## ADDENDUM NO. 2

### Rowland Unified School District

### Alvarado Intermediate School Partial Modernization

DSA No. 03-112358

**AD2-A1**

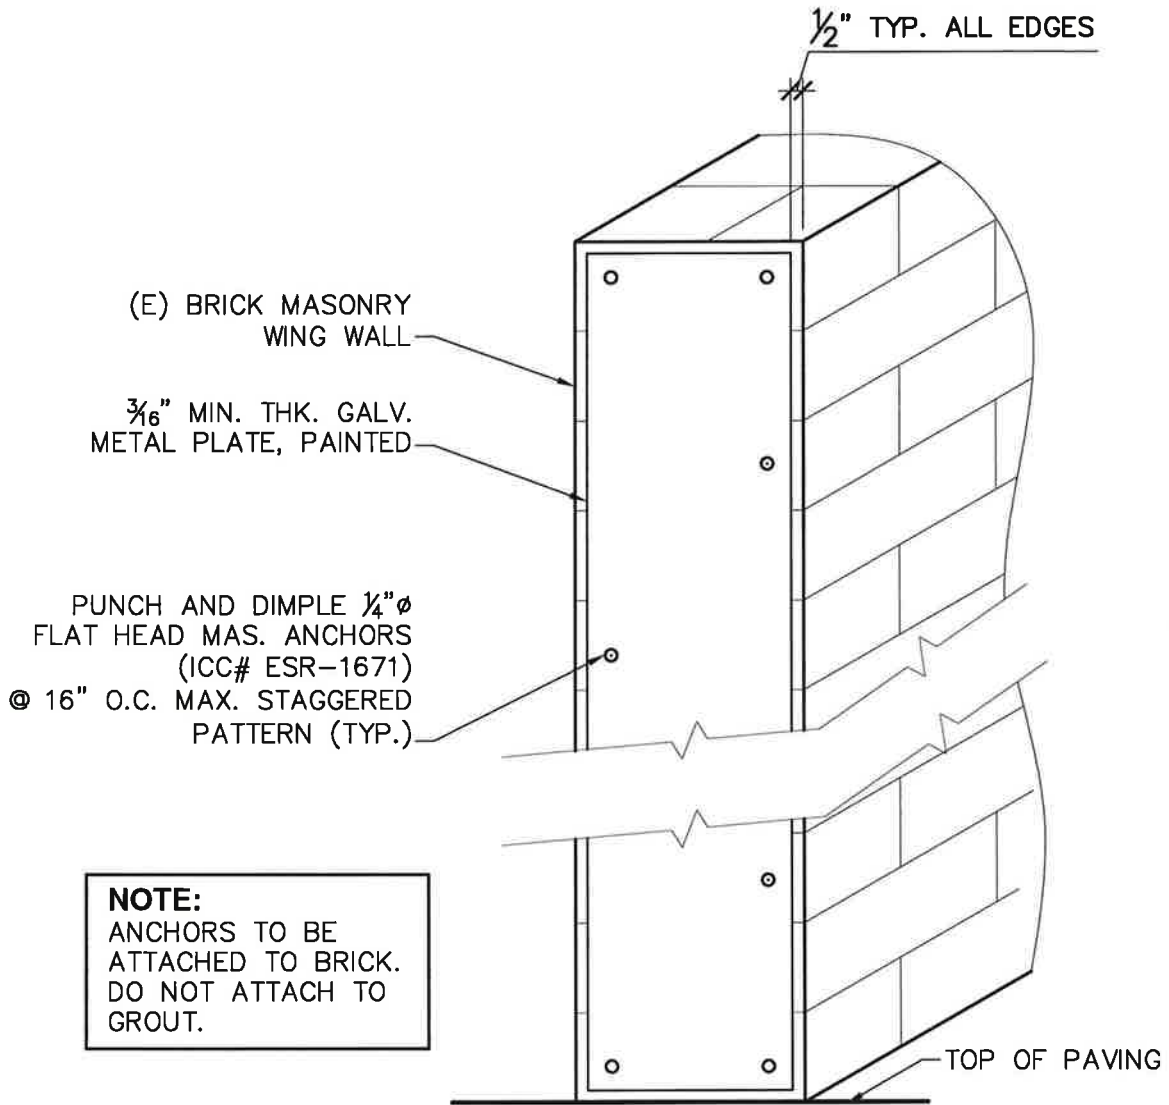
28. REVISE:  
TO READ: Key Note #21  
"21. Remove (E) H.M. gate frame. Patch and repair as required. (See attached drawing AD2-A1, dated March 7, 2011) (Typ. Throughout each building in entire school)"

36. REVISION: At Demolition Floor Plans  
REVISION: Key Note #16  
TO READ: "16. Remove (E) H.M. gate frame. Patch and repair as required. (See attached drawing AD2-A1, dated March 7, 2011) (Typ. Throughout each building in entire school)"  
On SHEET A-3.0

**AD2-A2**

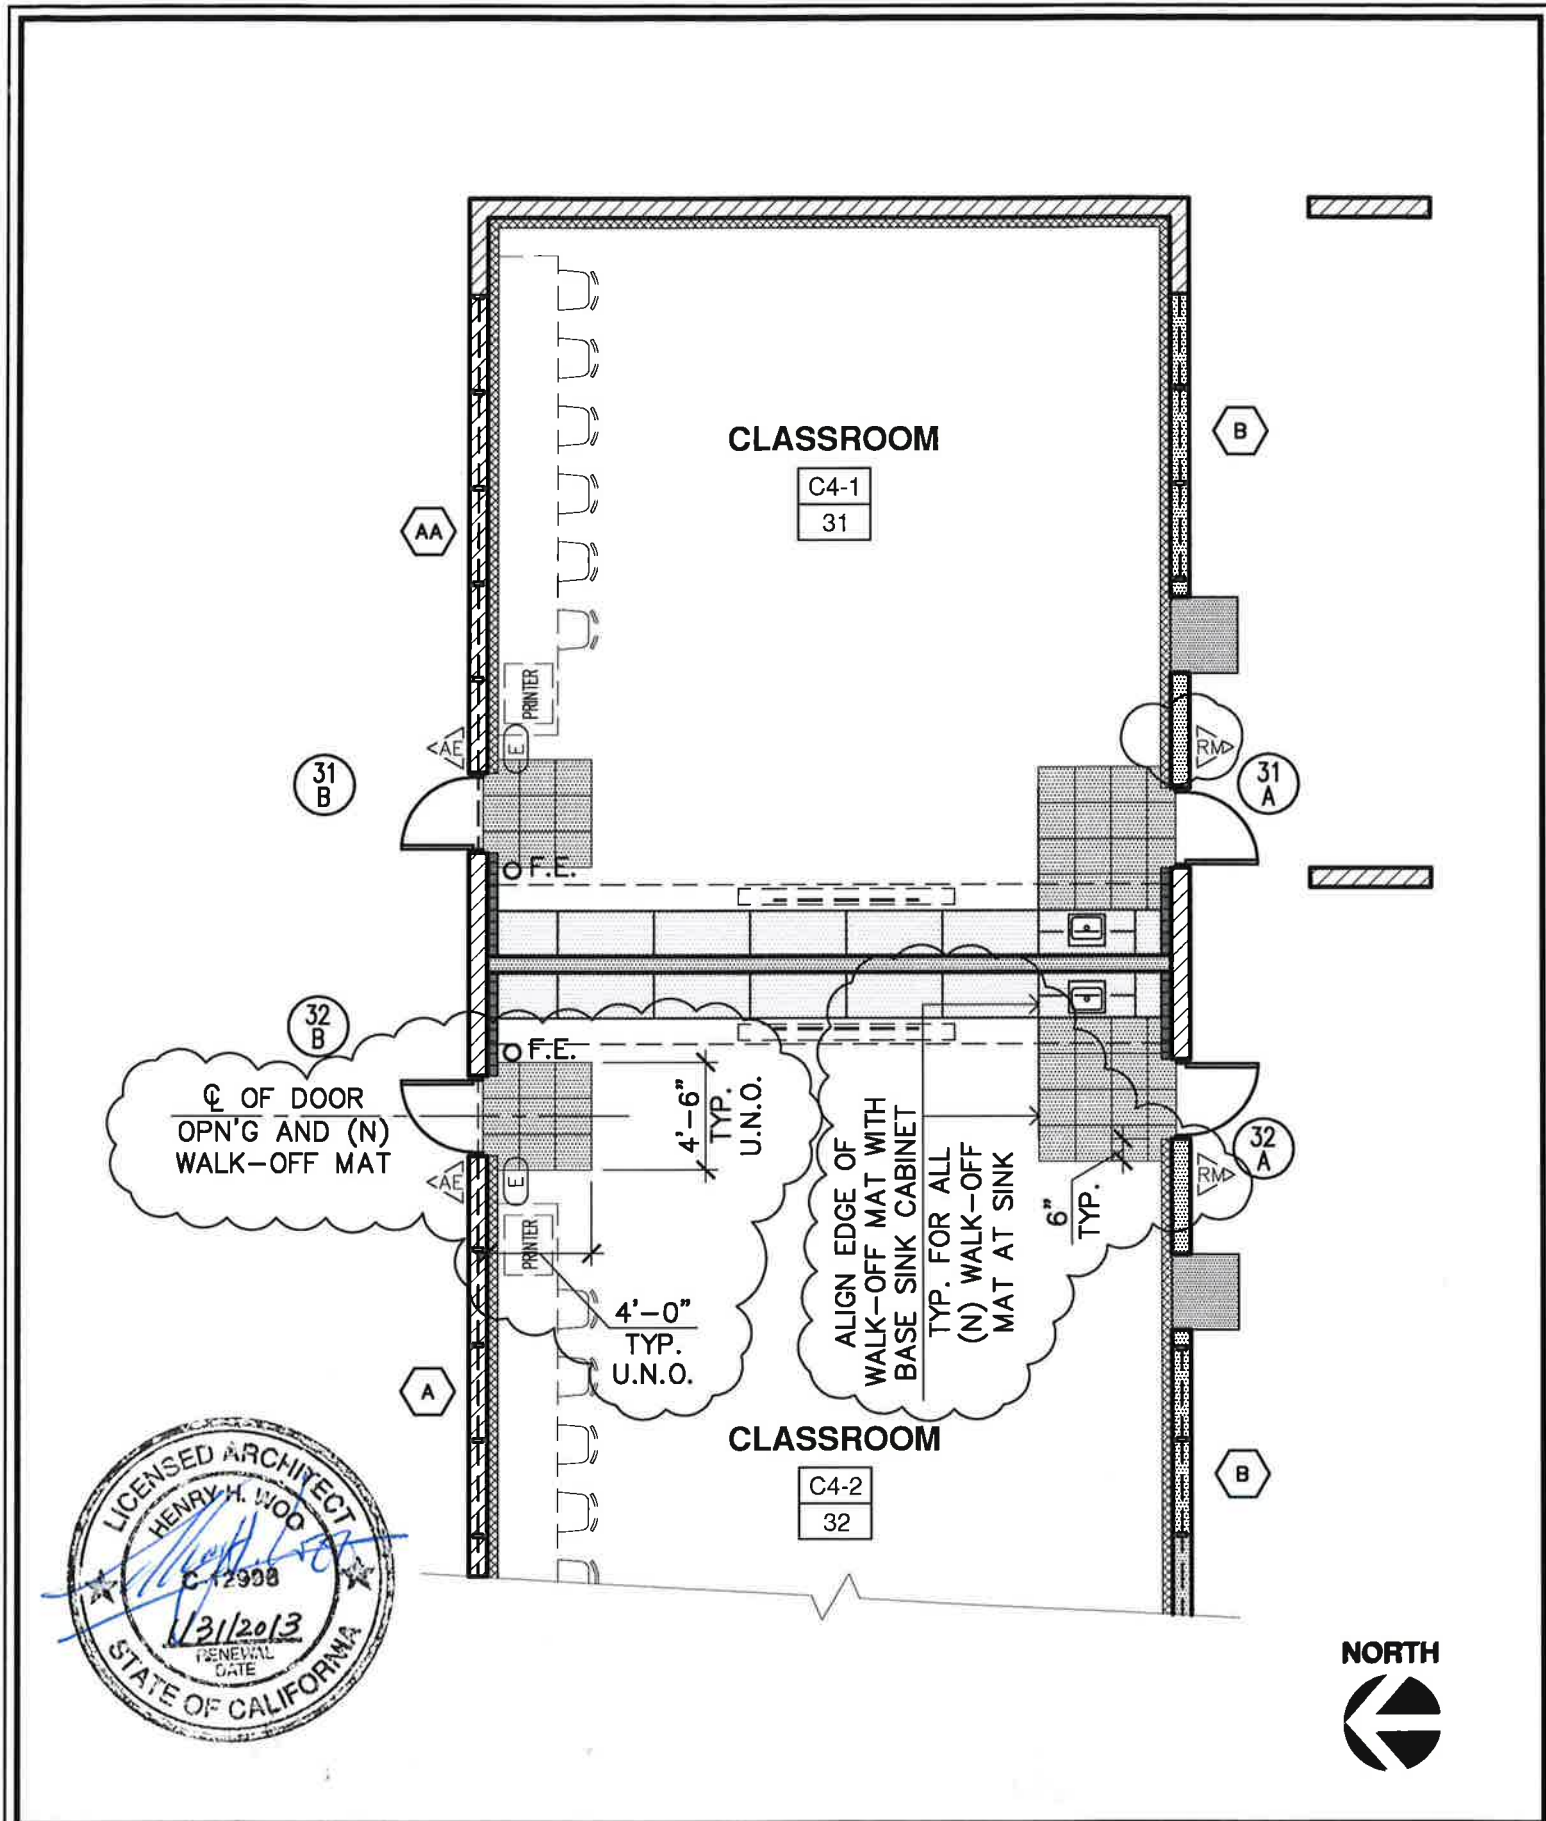
1. In lieu of all plan description, all new walk-off mats shall be Owner Furnished, Contractor Installed items (O.F.C.I.). Refer to attached drawing AD2-A2, dated March 7, 2011 for typical sizes and locations of new walk-off mat.

27. REVISE:  
TO READ: Key Note #16  
"16. Remove (E) walk-off mat and portion of (E) carpet for new walk-off mat installation (Typ.)"

**AD2-A3**

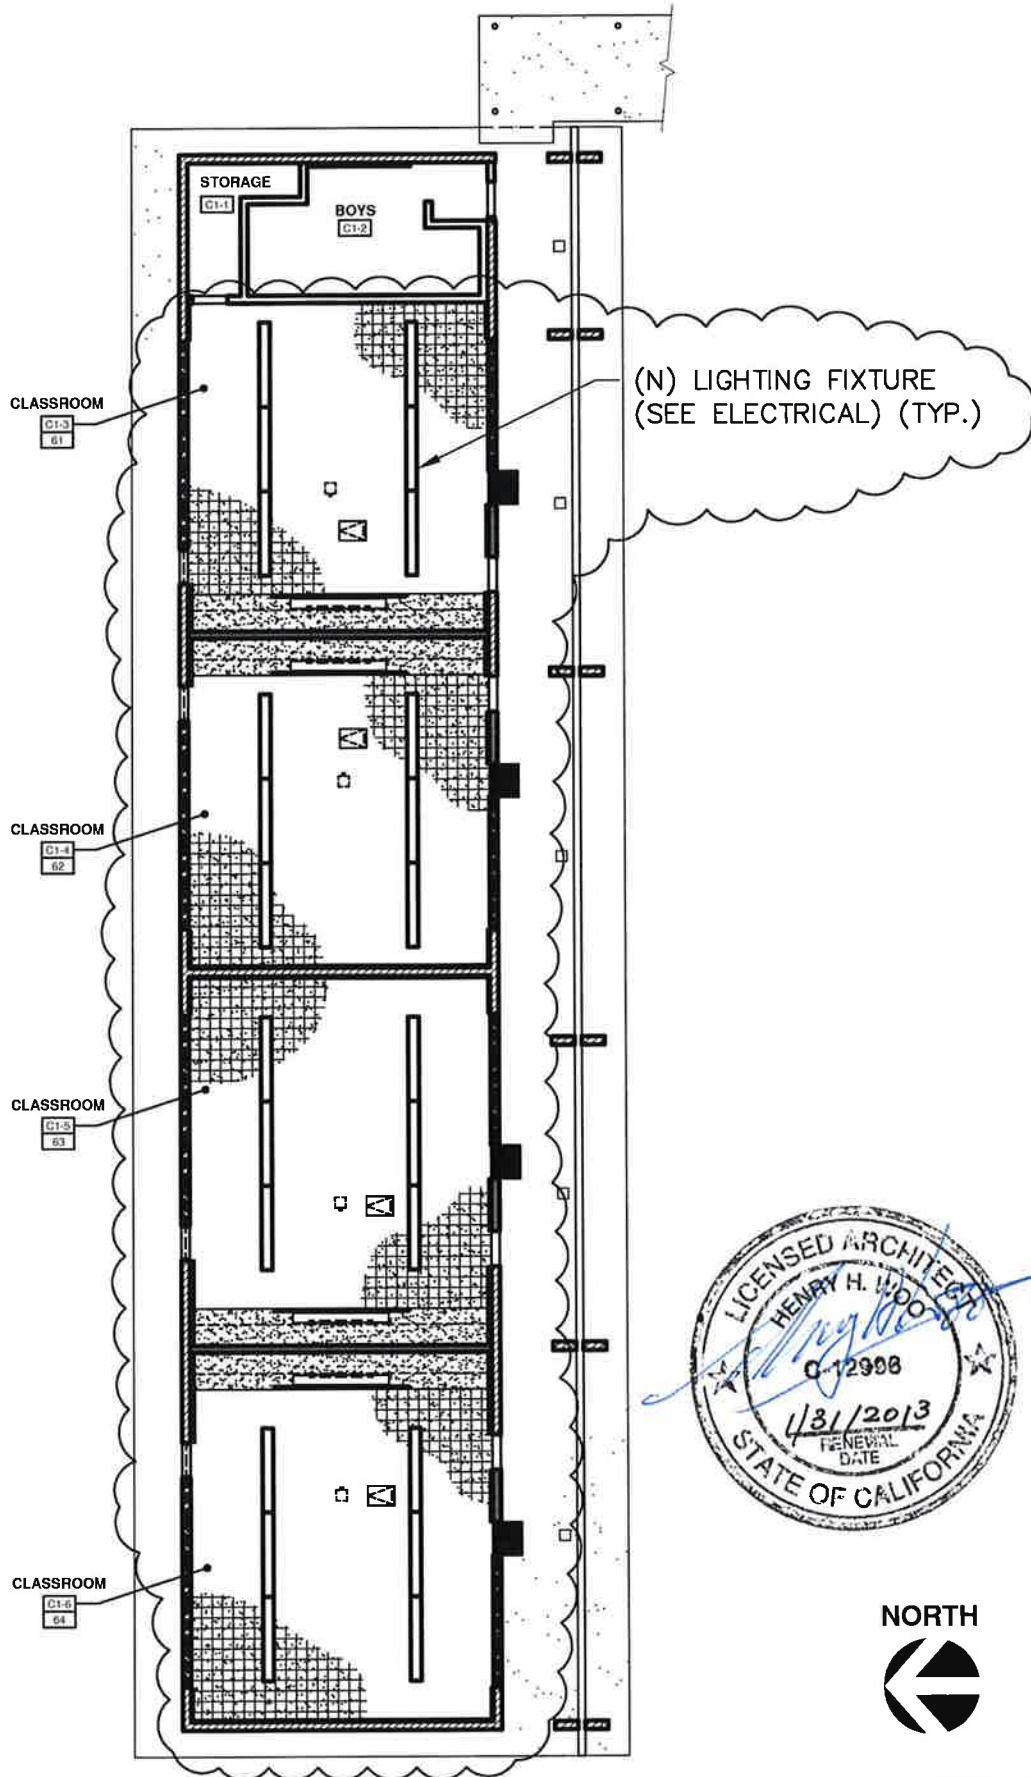
37. REVISION: At Reflected Ceiling Plan - Bldg. C-1 (Bldg. C-4, C-5, and C-6 Similar), and bldg. C-3  
REVISION: Per attached drawing AD2-A3 and AD2-A4, dated March 7, 2011.

**AD2-A5**

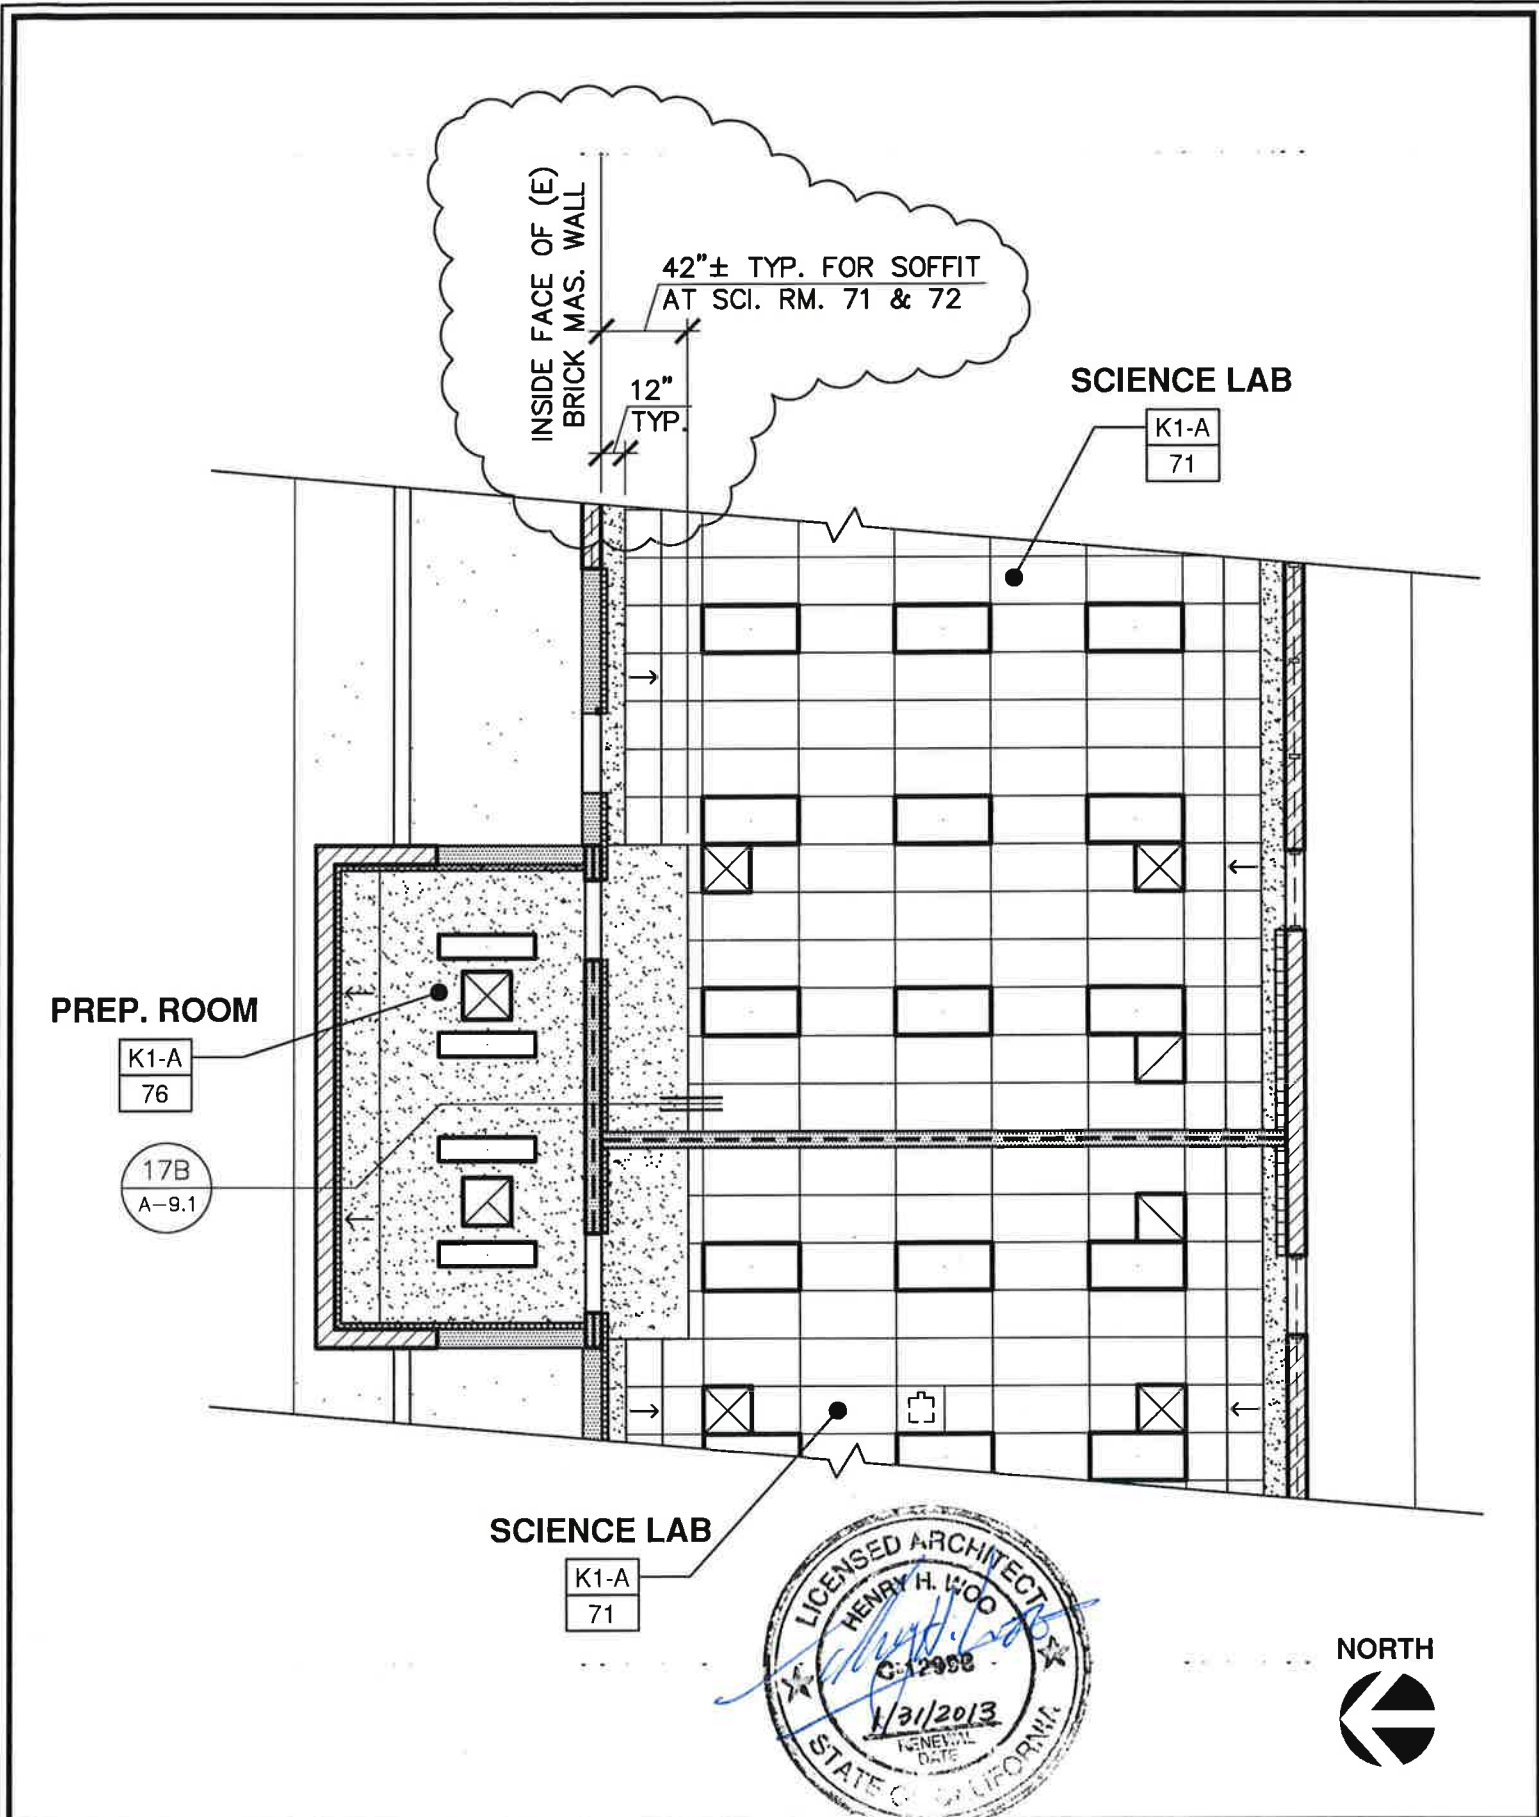
38. Refer to attached drawing AD2-A5, dated March 7, 2011 for dimension of new soffit at Science Lab 71 and 72.  
On SHEET A-5.0
39. REVISION: At South Exterior Elevation of Bldg. C-2  
REVISION: Revise per attached drawing AD2-A6, dated March 7, 2011.

**AD2-A8**

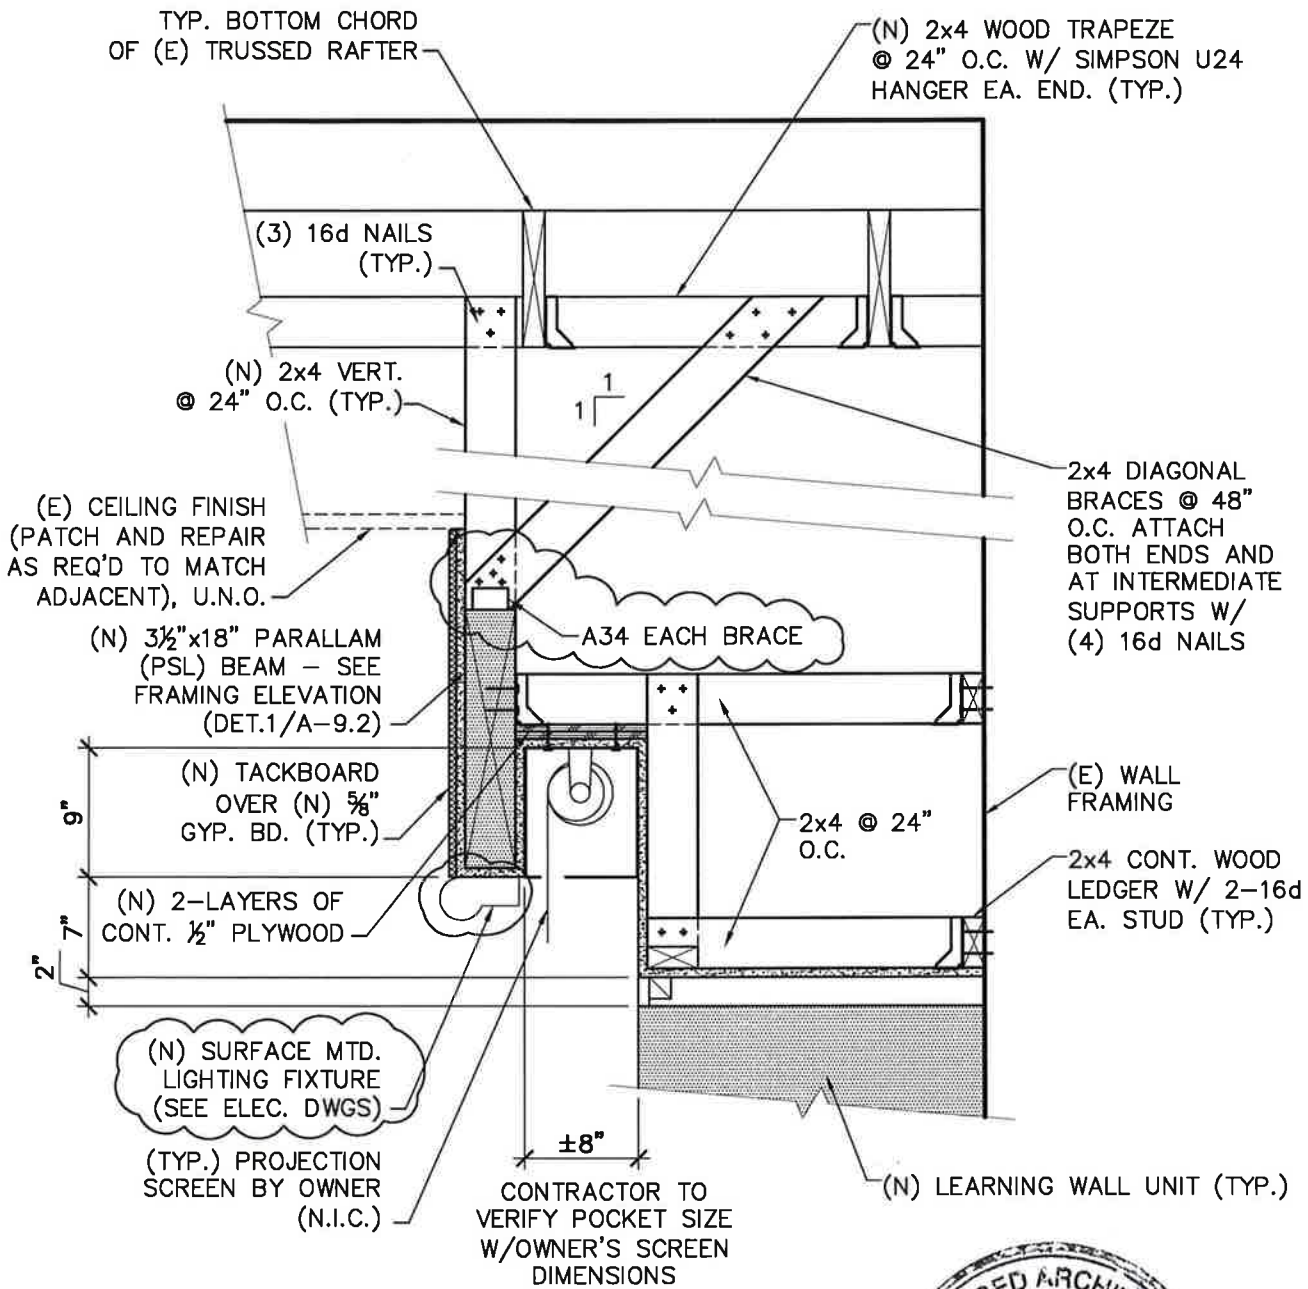
42. REVISION: At Detail 4 - Typical Exterior Door  
REVISION: Detail per attached drawing AD2-A7, dated March 7, 2011.  
On SHEET A-9.2
43. REVISION: At Detail 12B - Typical Soffit  
REVISION: Detail per attached drawing AD2-A8, dated March 7, 2011.
